TOWN OF BLUFFTON

STAFF REPORT

MEETING DATE:	January 27, 2016
PROJECT:	Nissan & Infiniti Dealerships – Certificate of Appropriateness – Highway Corridor Overlay
PROJECT MANAGER:	Erin Schumacher, AICP, Senior Planner

1. **COFA-12-15-9448.** A Certificate of Appropriateness to allow the development of two car dealerships consisting of two buildings ranging in size from 18,000 SF to 25,000 SF and associated site improvements on approximately 11 acres of property fronting US Highway Route 278, zoned Buckwalter PUD within the Buckwalter Business Park Master Plan.

dwg. title
LIGHTING
SITE PLAN

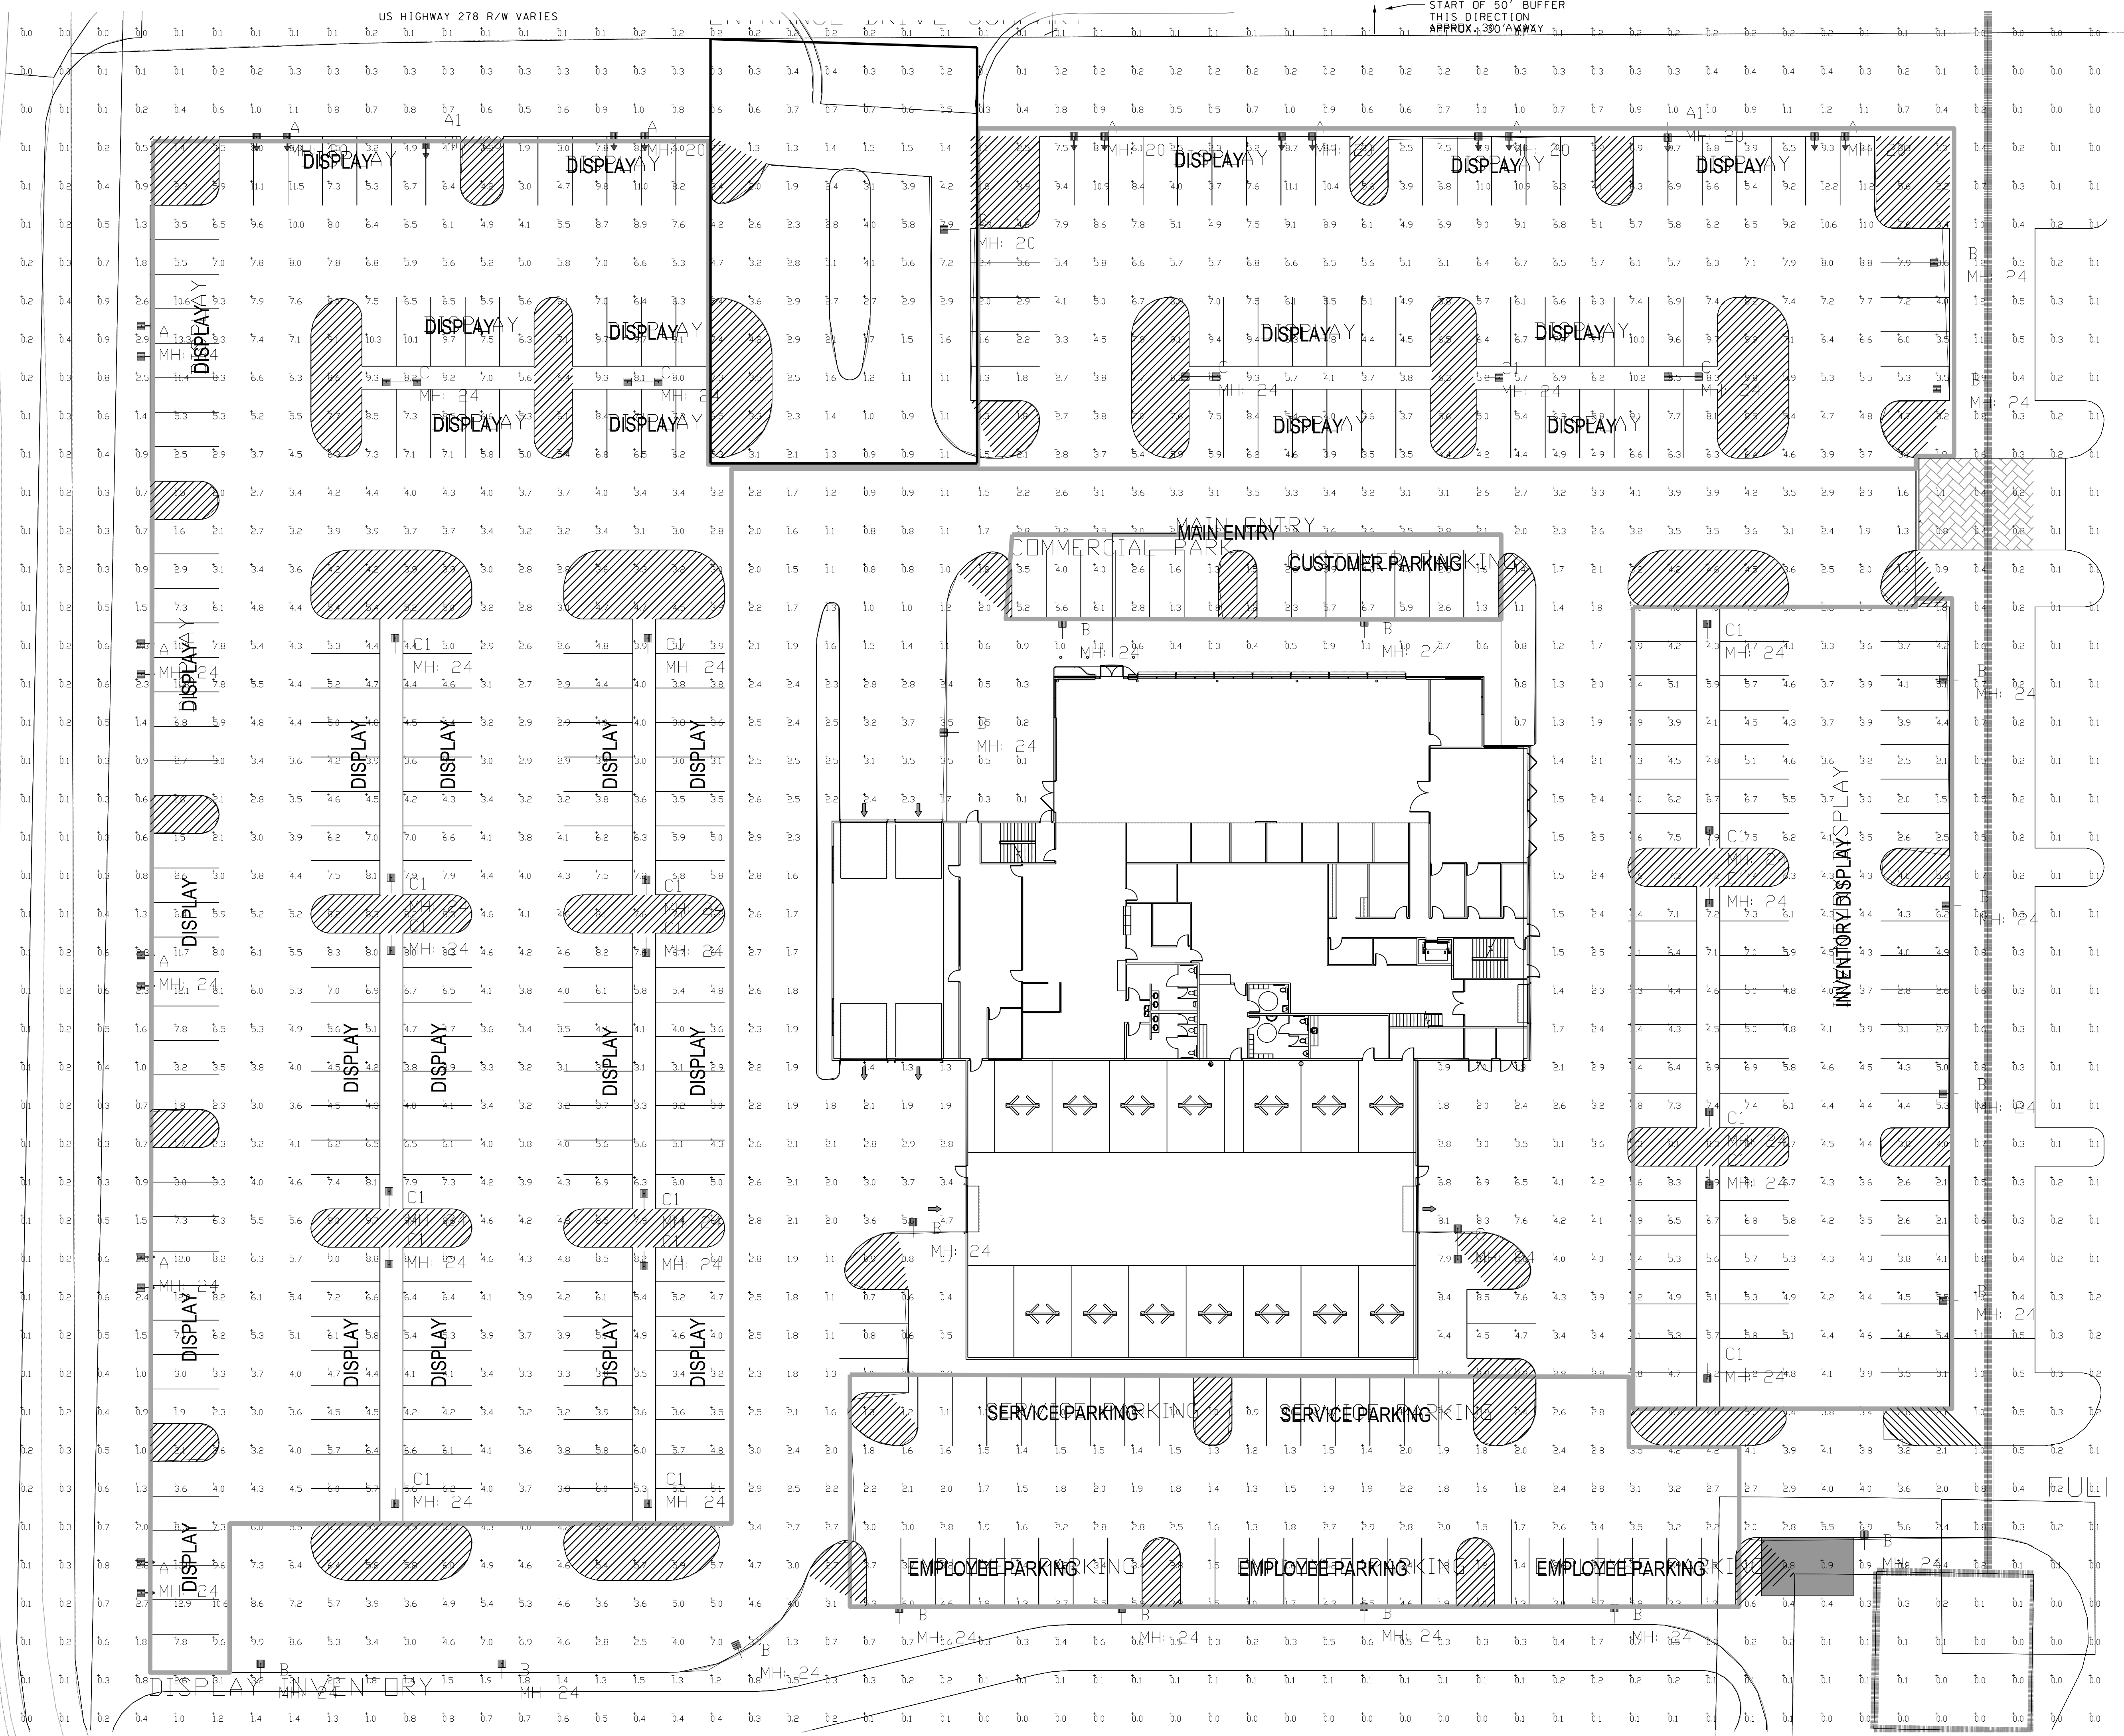
Town Staff finds that the average illumination levels for nearly all types of lighting exceed those levels noted in the ZDSO. The proposed lighting does not meet the requirements and must be modified not to exceed the averages listed.

- a. Per Section 4.23.3.C.2.a.2 of the Beaufort County ZDSO, the Planning Commission find the use of LED lighting to be an appropriate substitute for the permitted light source.
- b. Per Section 4.23.3.C.4. of the Beaufort County ZDSO, the average illumination levels for the proposed lighting must be modified not to exceed the averages permitted.
